S E R V I C E**N O T E**

Supersedes:
E8356A-02B

E8356A PNA Series RF Network Analyzers

August 14, 2007

Figure 1

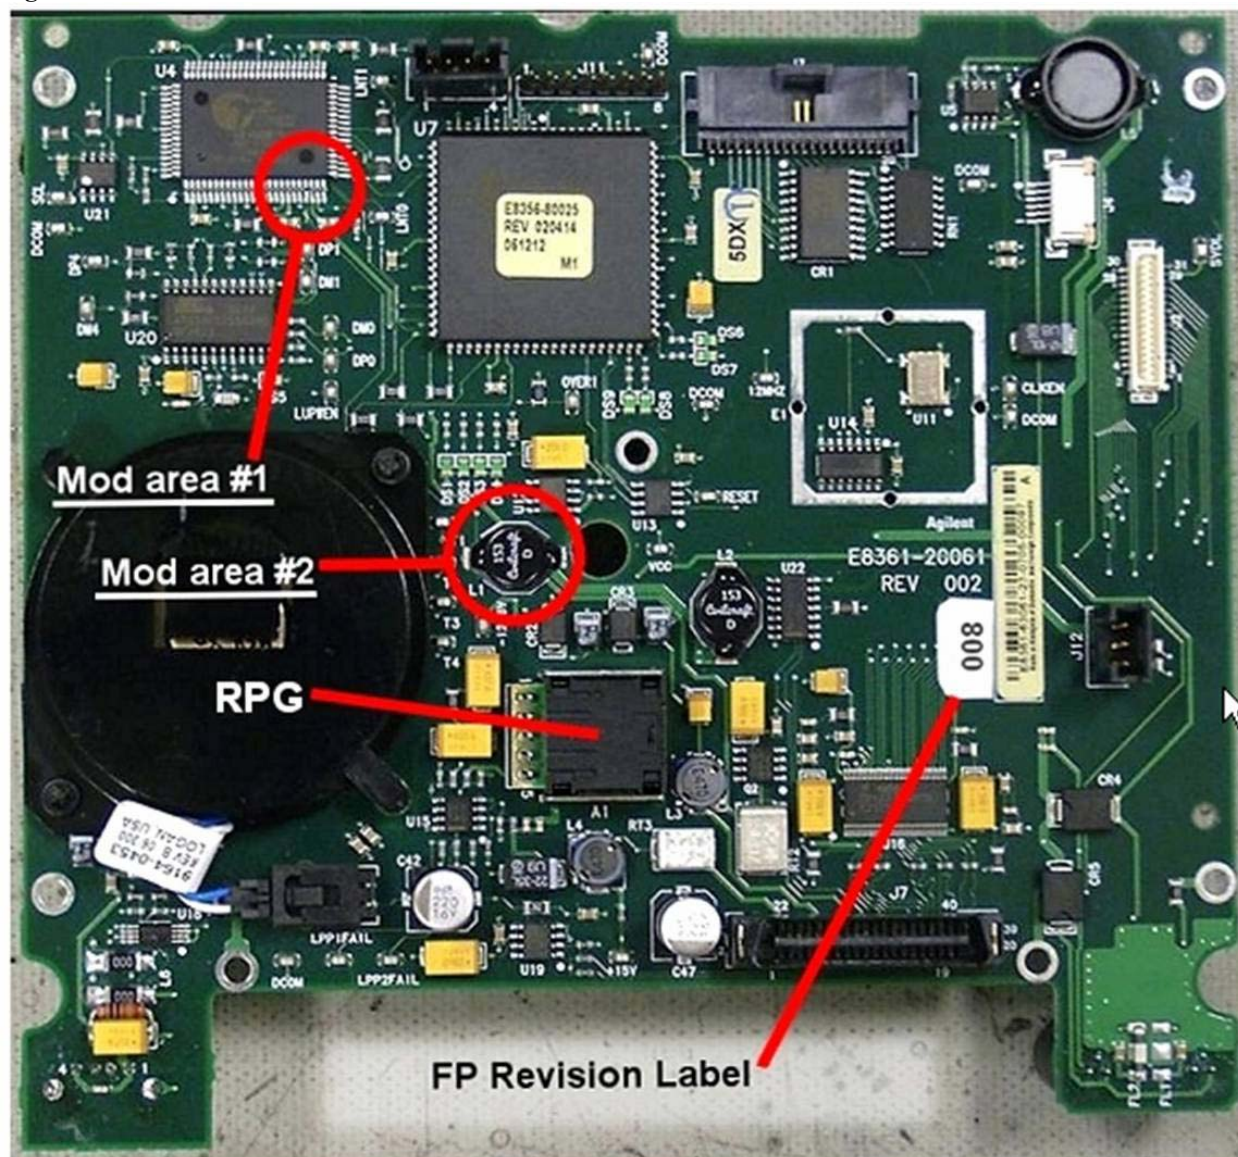
Refer to Figure 1 for the two modification areas to be addressed. Note that while this picture happens to show the FPI board completely removed from the front frame assembly, this is not necessary to perform the required modifications.

- Modification #1 consists of shorting two pins of U4 together with a small amount of solder.
- Modification #2 consist of removing L1.

Figure 2

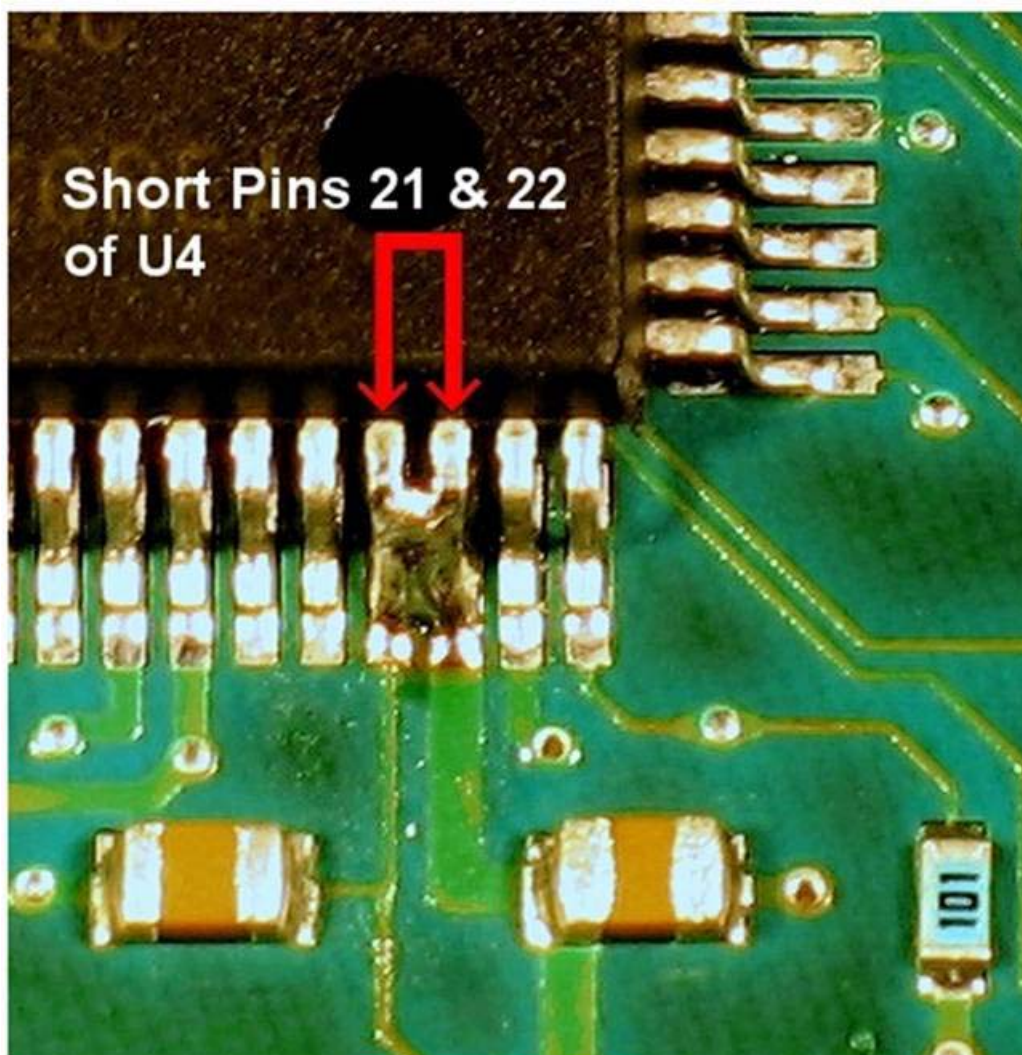
Carefully solder pins 21 and 22 together on U4. Refer to Figure 2 for the exact location. Use care so that no other pins are shorted. Use of a very fine tip soldering iron is recommended and a large work-task magnifying glass is very helpful.
